BASIC PERMIT PACKAGE
REVIEWED FOR CODE COMPLIANCE
WITH IRC 2015
KITSAP COUNTY BUILDING DEPARTMENT

a new model home for
Disney & Associates

Plan 2322

A4

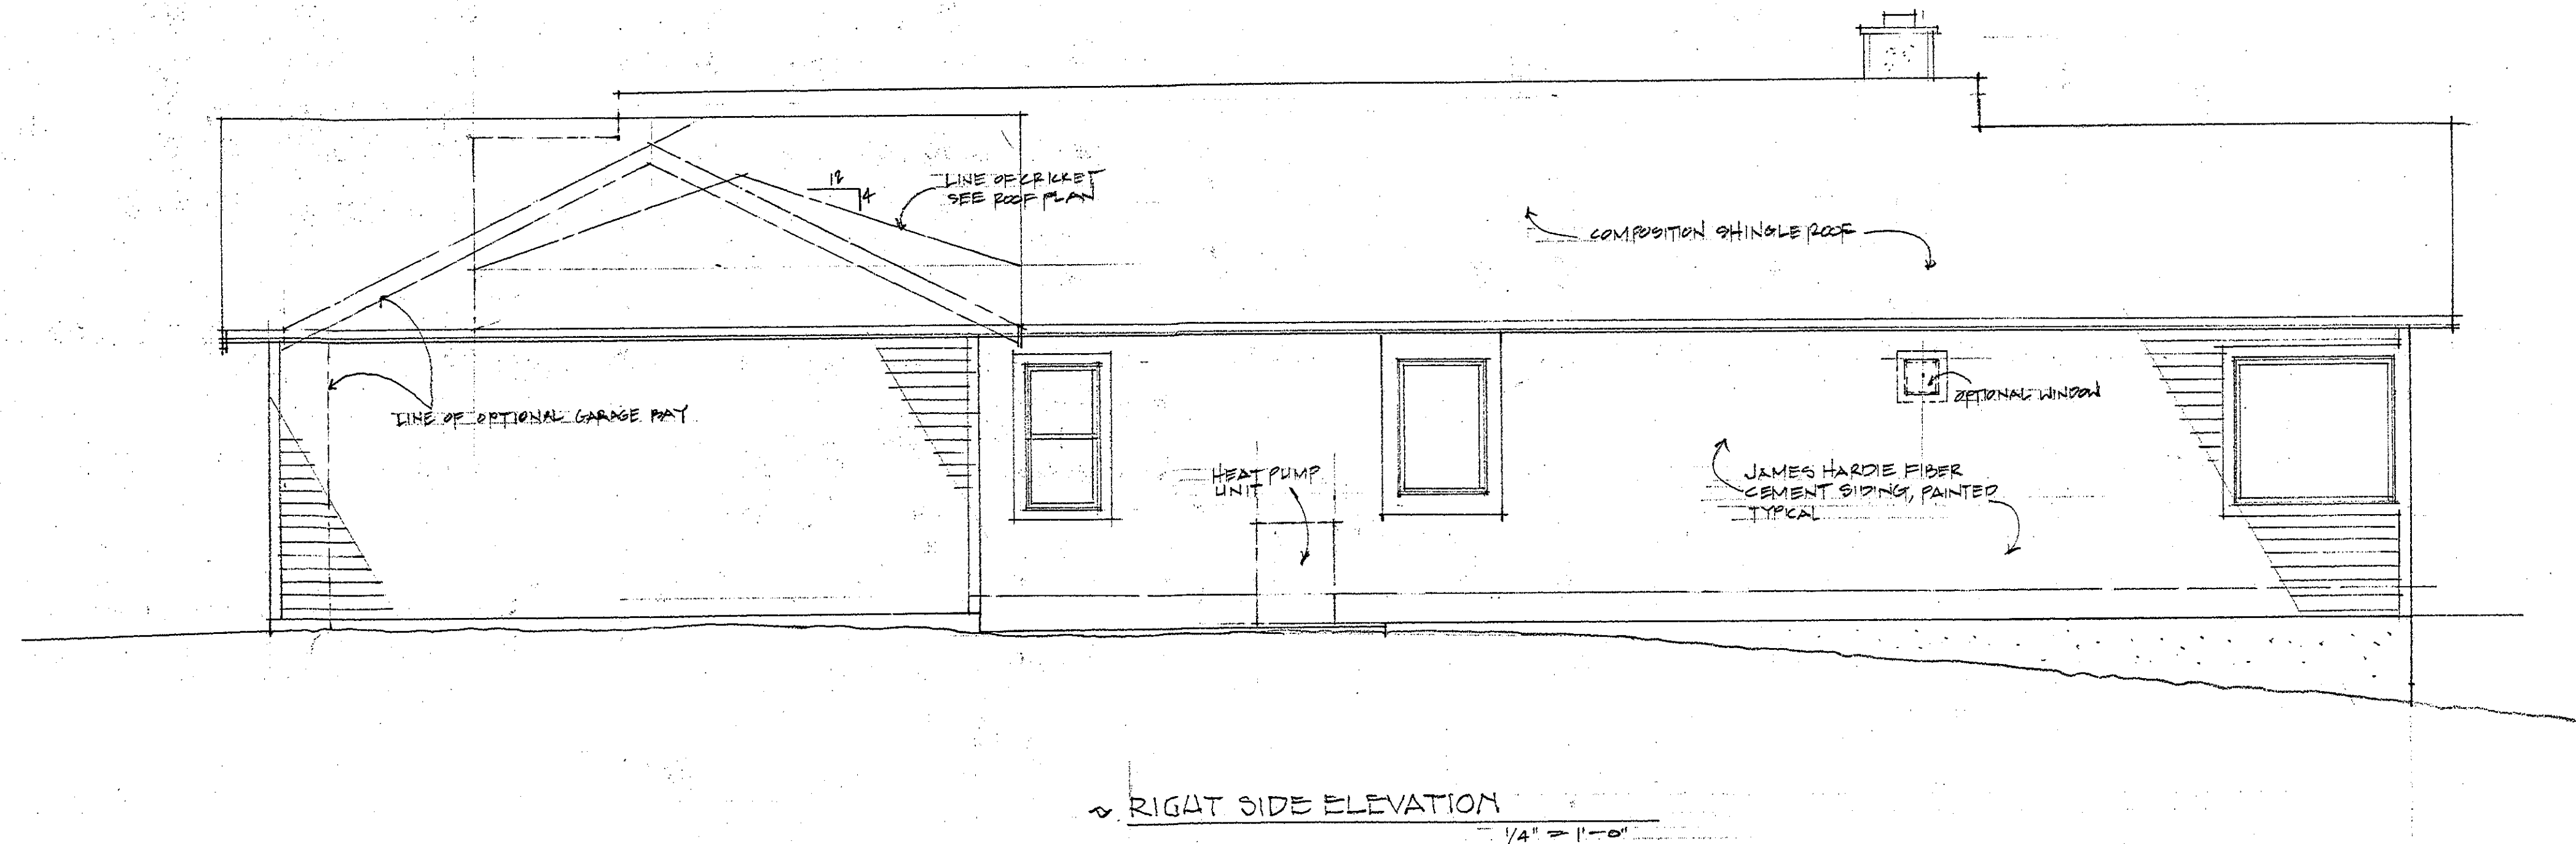
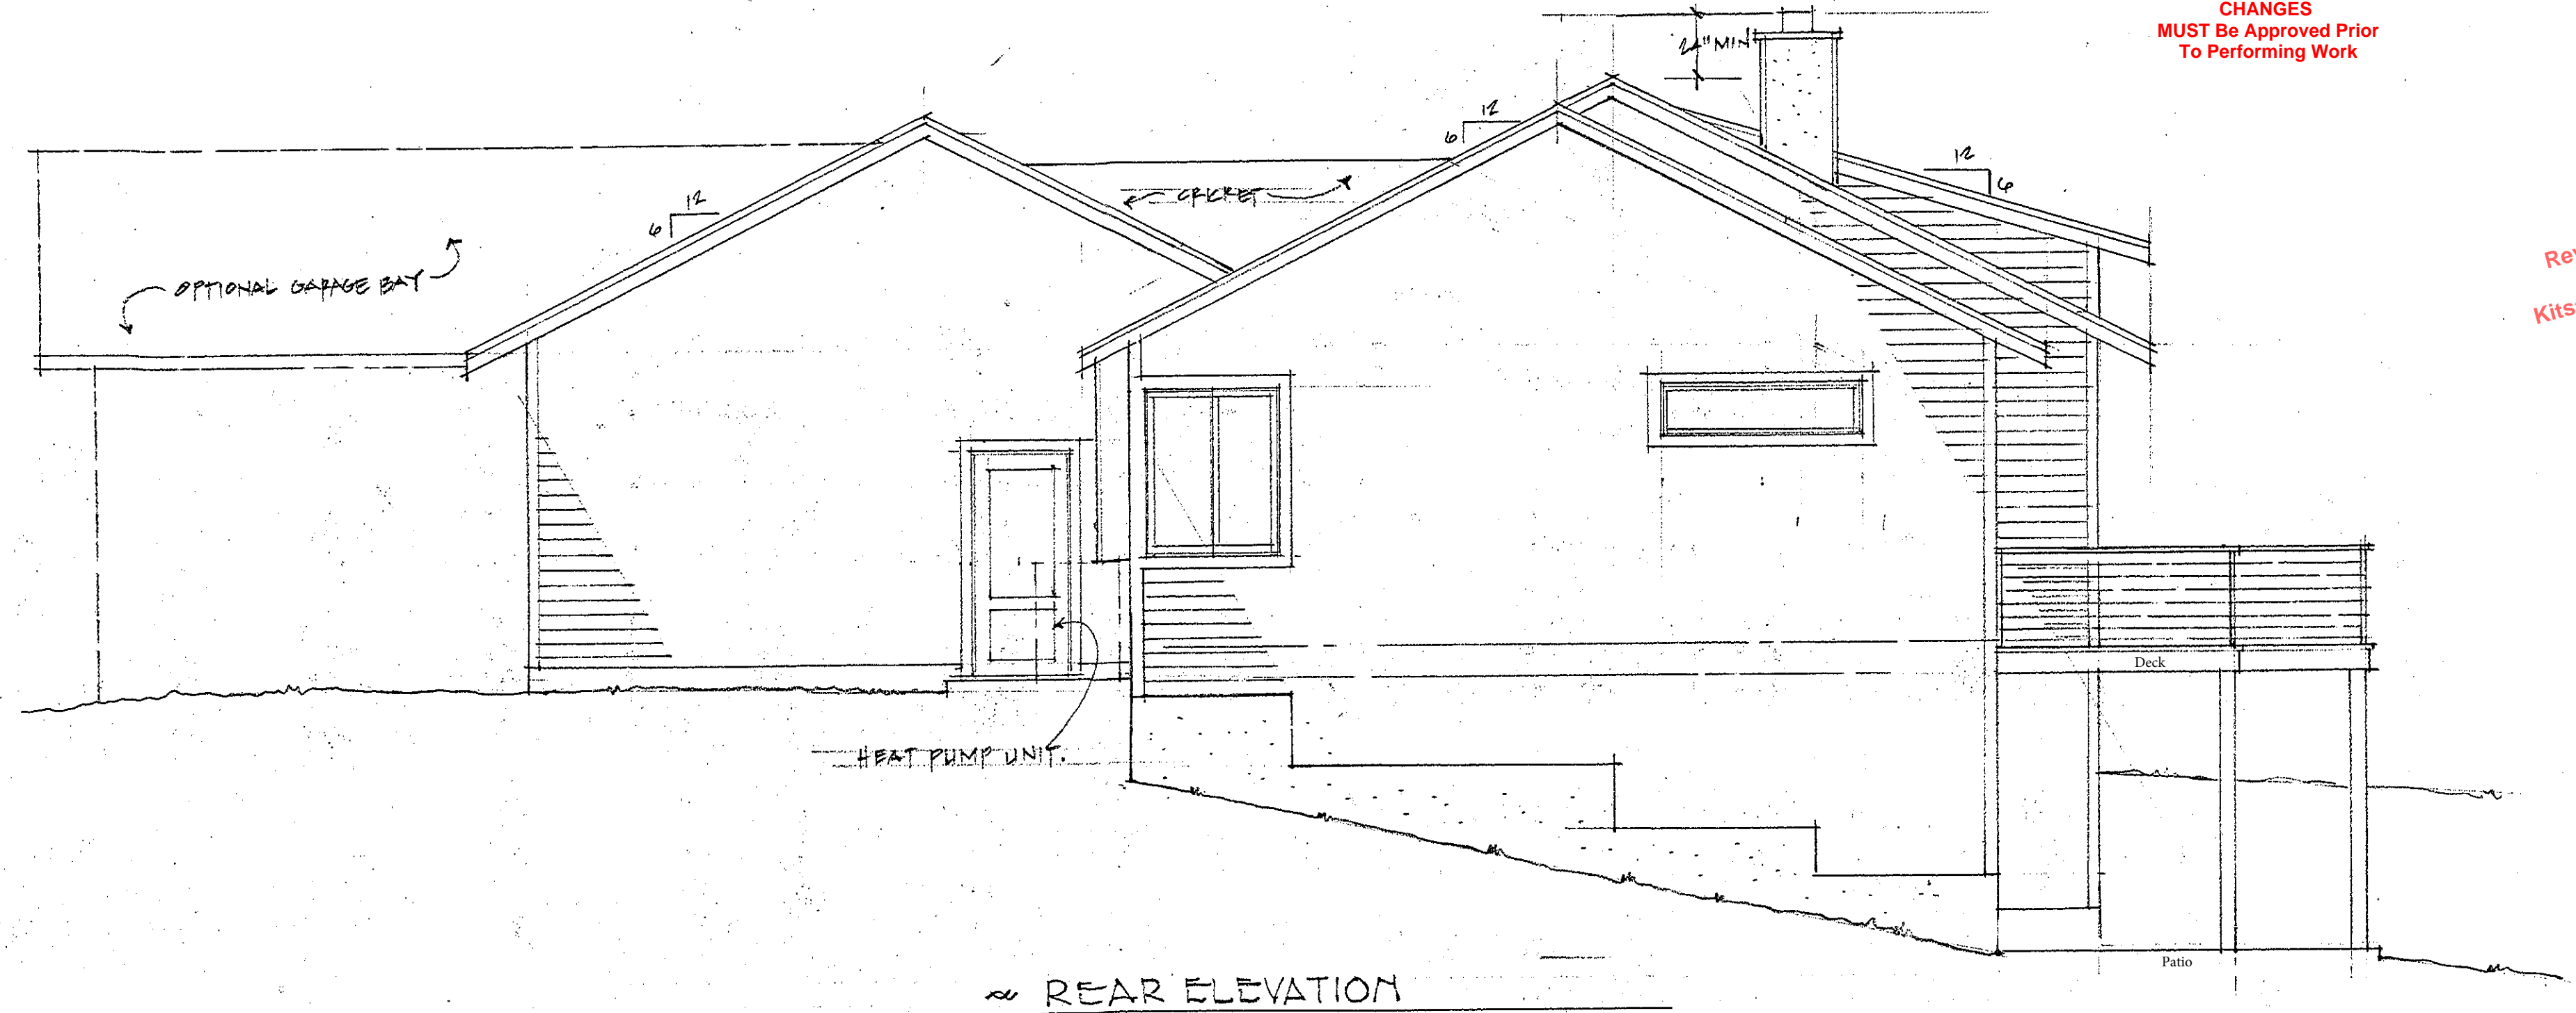
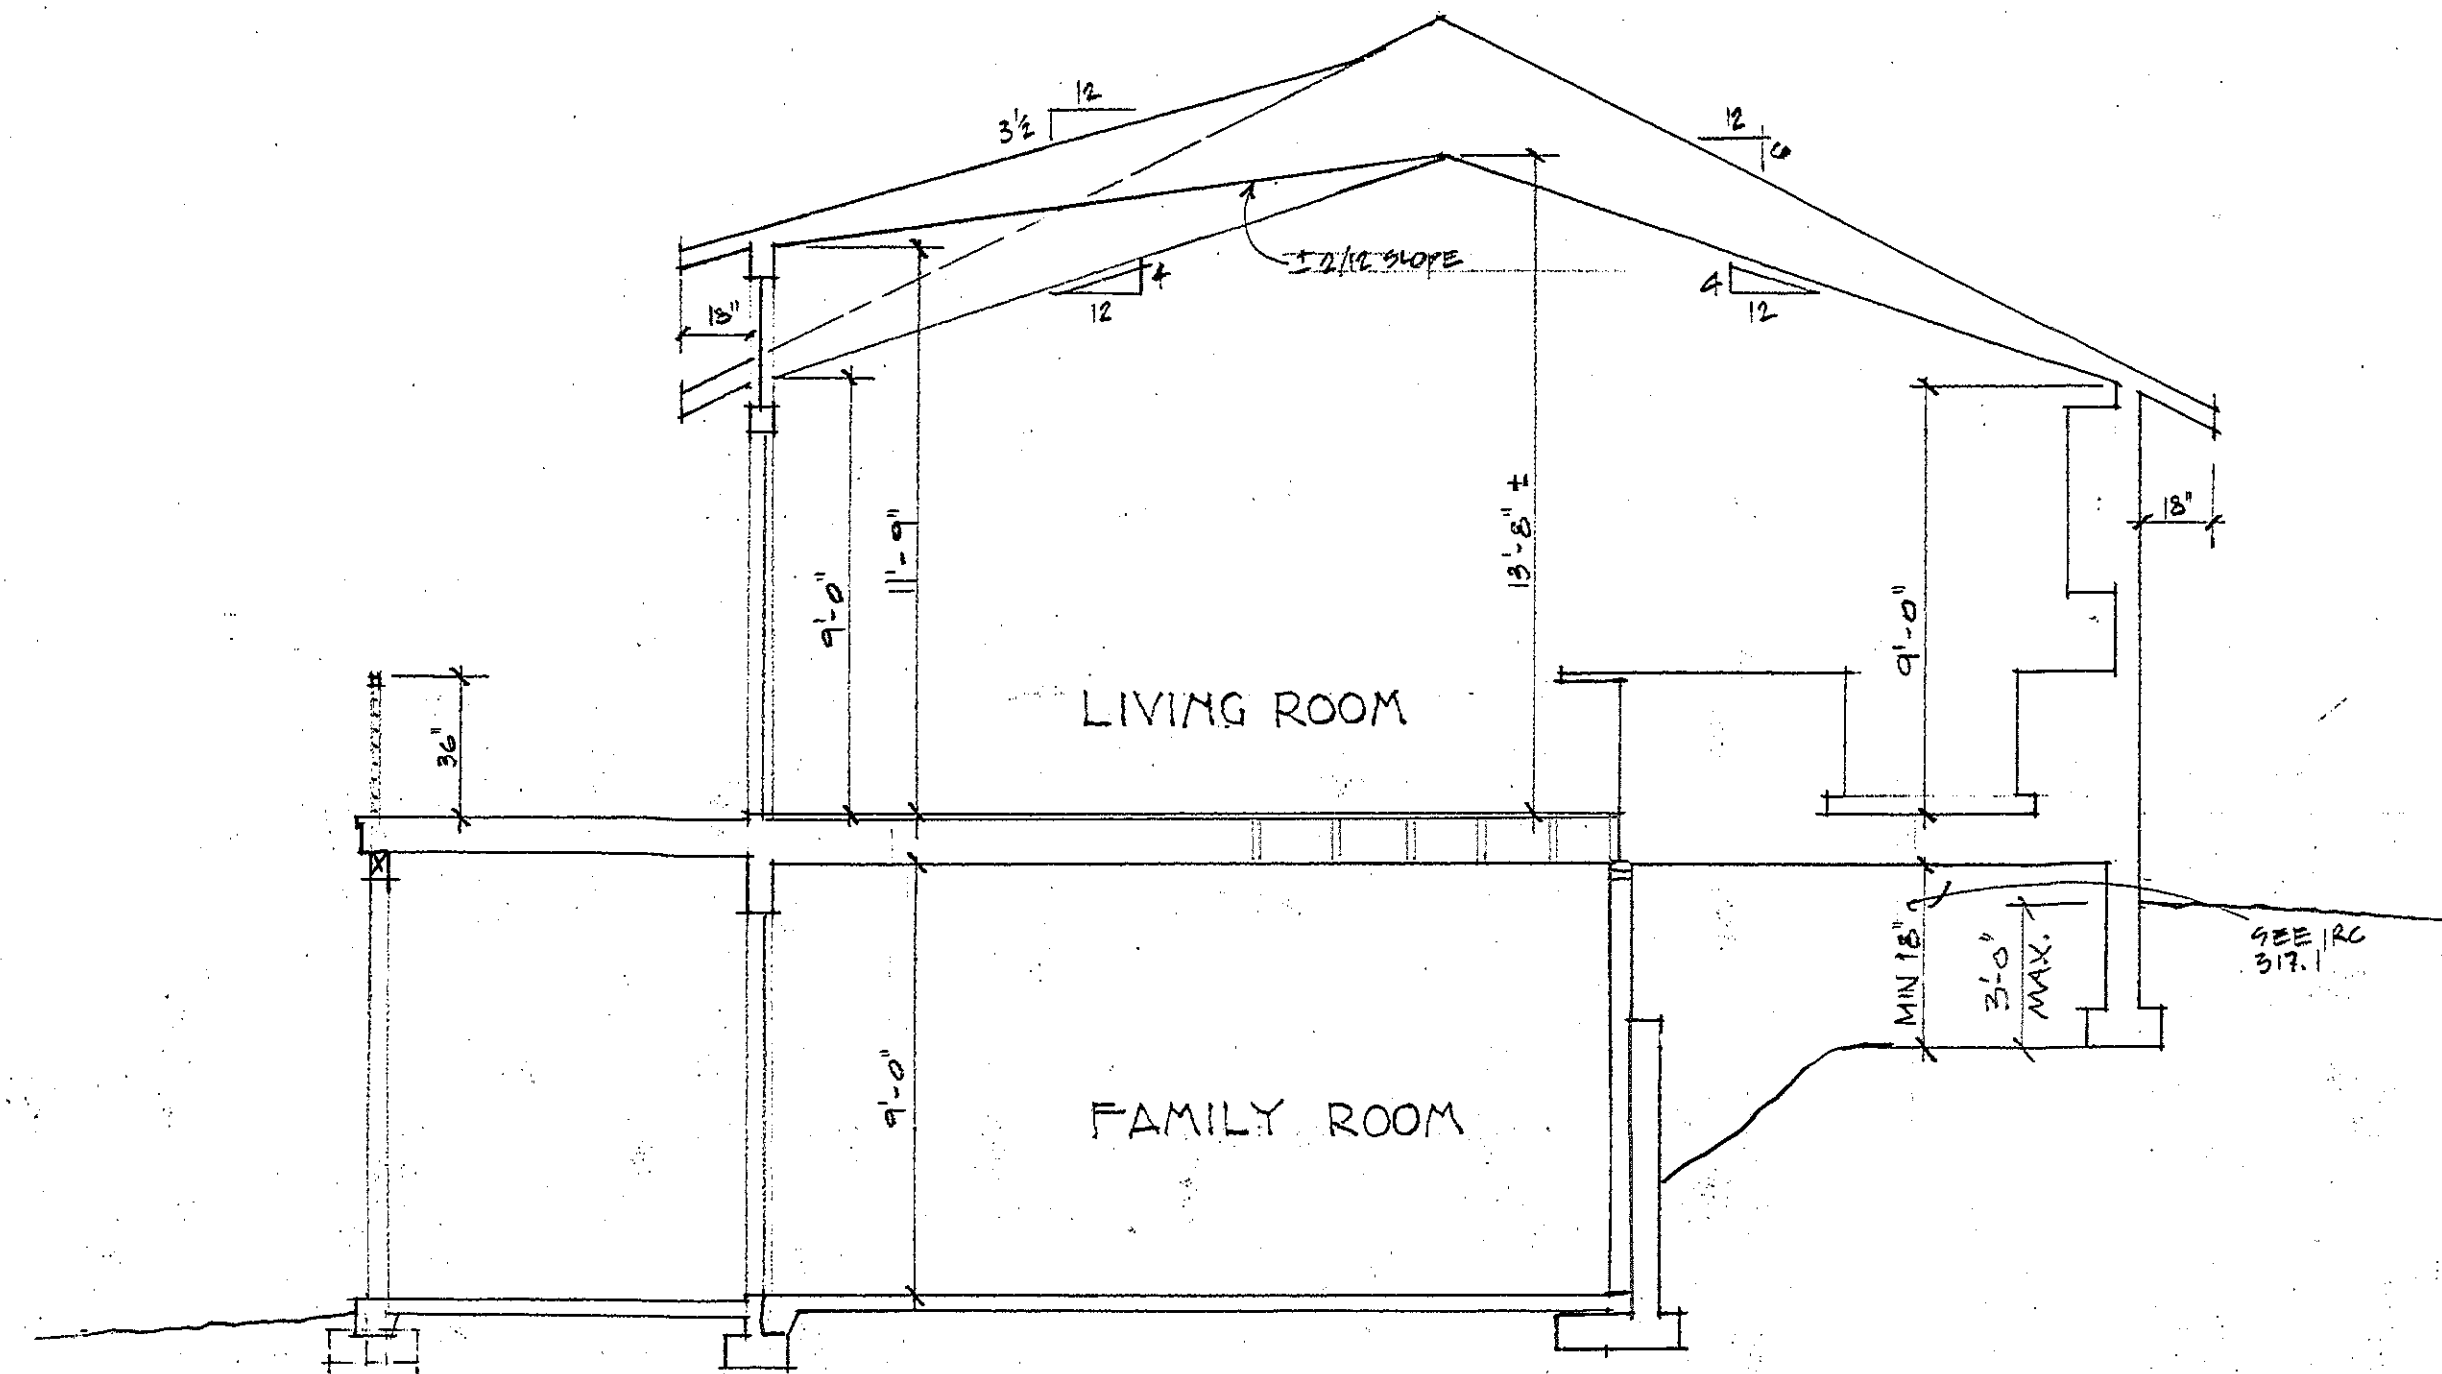
Gutters and downspouts are required.
All roof and yard drains shall be directed to splash blocks at a minimum,
or to an infiltration system if required. All surface drainage shall have a
minimum 2% grade away from the foundation.

Depending on site conditions,
stairs may be present
